SUSITNA HYDROELECTRIC PROJECT

SUBTASK 6.08 - PRELIMINARY DEVIL CANYON
ALTERNATIVES

MINUTES OF MEETING HELD
IN BUFFALO 9, 10TH DECEMBER 1980

MINUTES OF MEETING
held at the offices of
Acres American Incorporated
on Tuesday and Wednesday, December 9-10, 1980

Dam Layouts at Devil Canyon and Watana

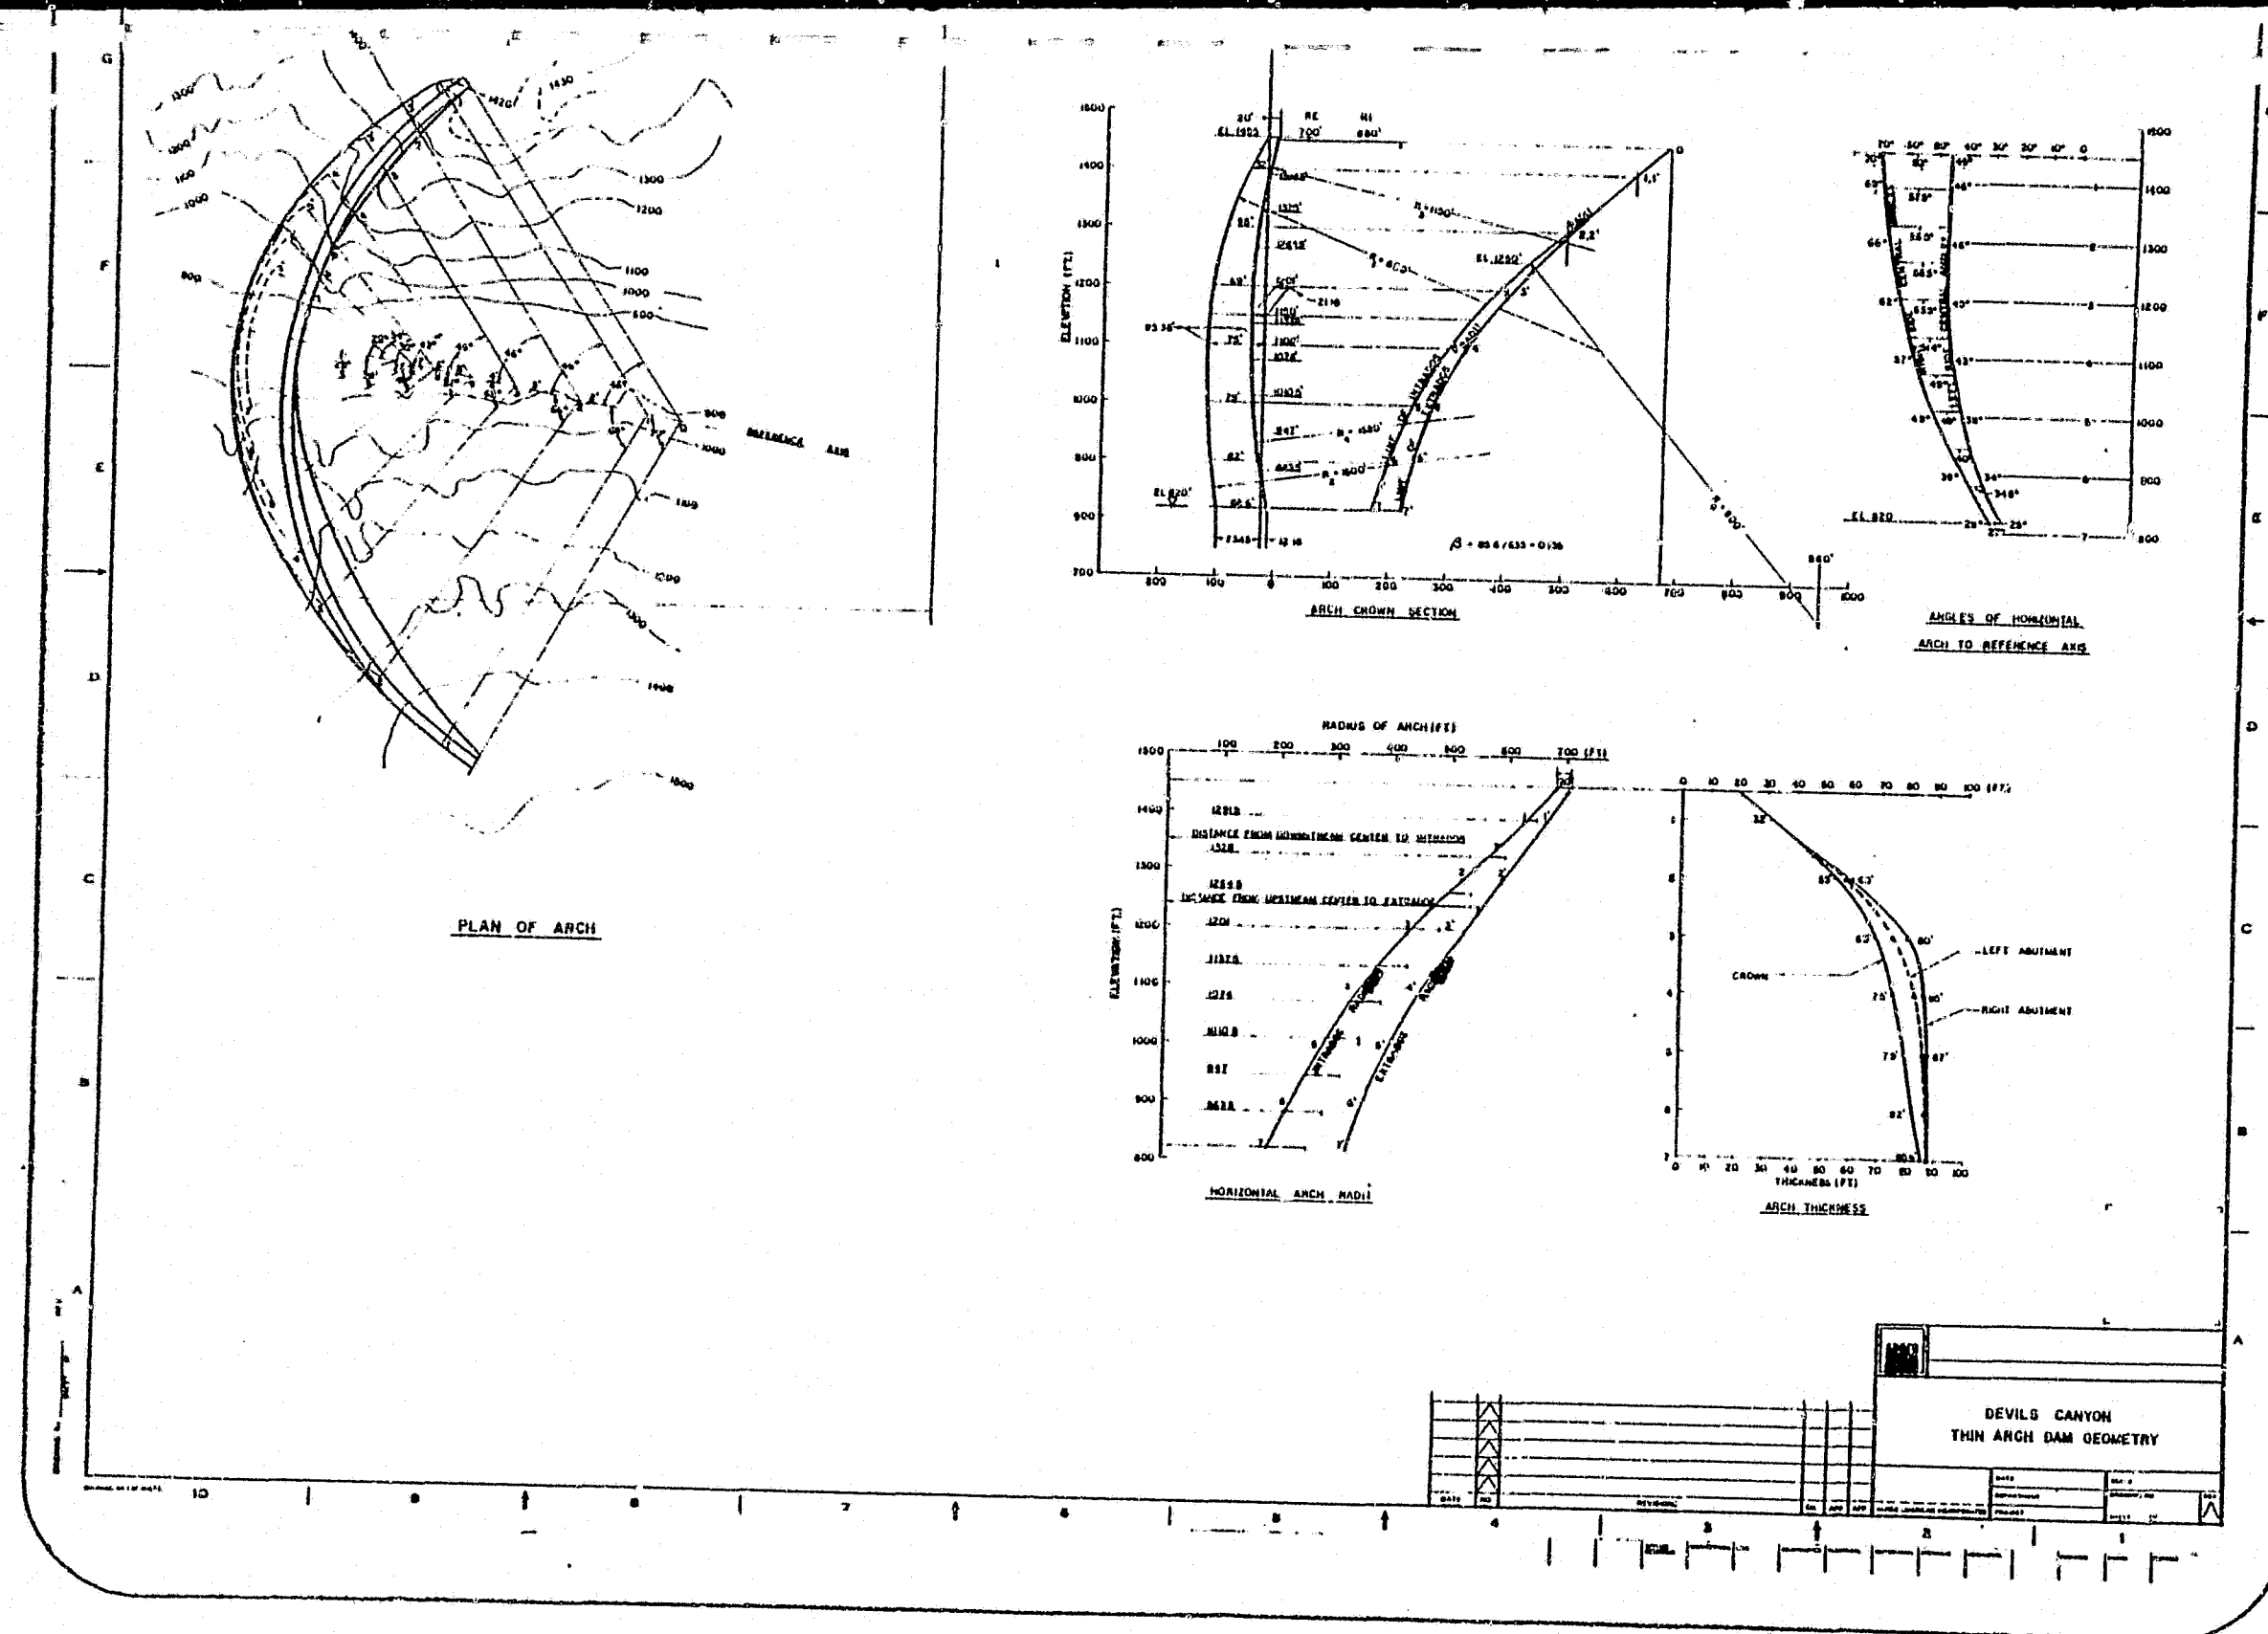
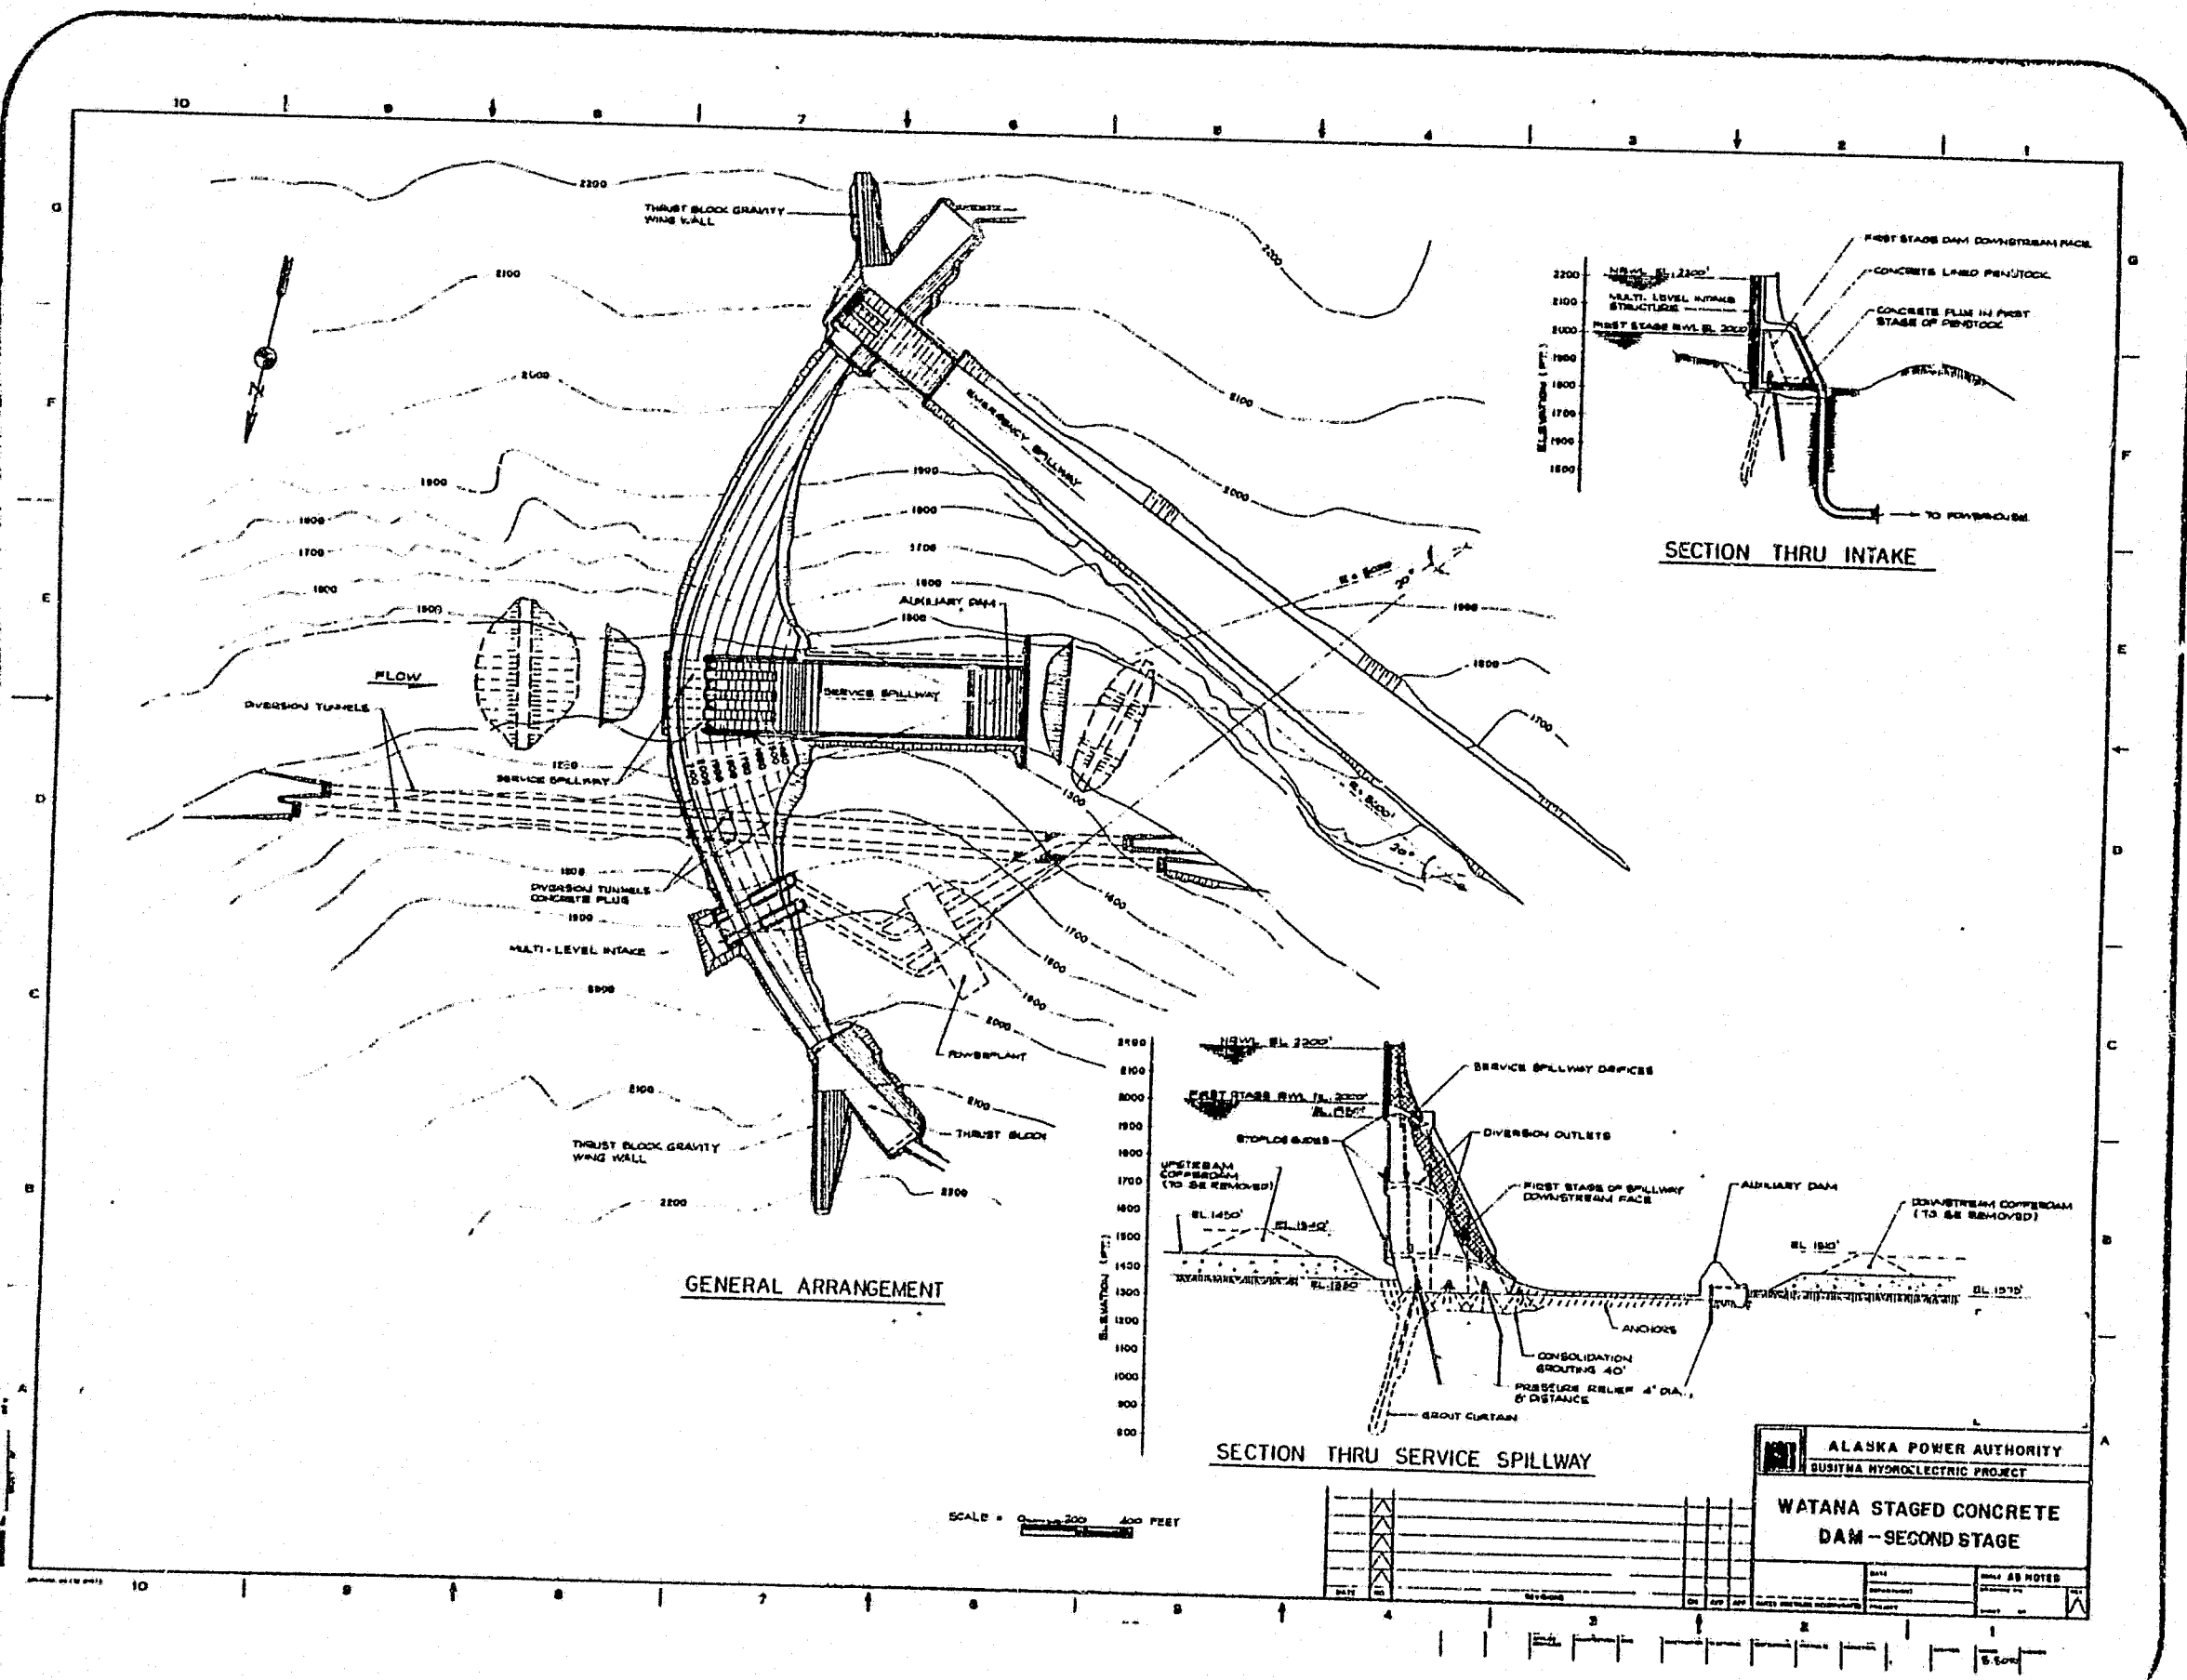
Some of the dam layouts discussed are included in Attachment 8. Copen indicated a thin arch dam was more appropriate for the site and questioned the high cantilever tensile stresses on the downstream side obtained by Acres. He indicated the aim should be to design the arch for no tension under normal (hydrostatic, gravity and temperature or H, G&T) loading conditions. He also indicated that selection of dam type should be based firstly on a safety consideration and secondly on economic considerations. He did agree that comparison of dam safety for various dam types was difficult, particularly comparison of fill versus concrete dams.

Acres briefly tabled a preliminary arch dam layout for the Watana site (see Attachment 8). M. Copen's comments were as follows:

- Watana is a good site for a 3 centered arch;

- in staging the dam, one should not consider adding concrete to the downstream face because of bonding difficulties which cause adverse temperature stress differentials. The height can be increased by merely adding concrete to the top of the dam;
- appropriate dam dimensions would be 100'-150' base width and 30' crest width.
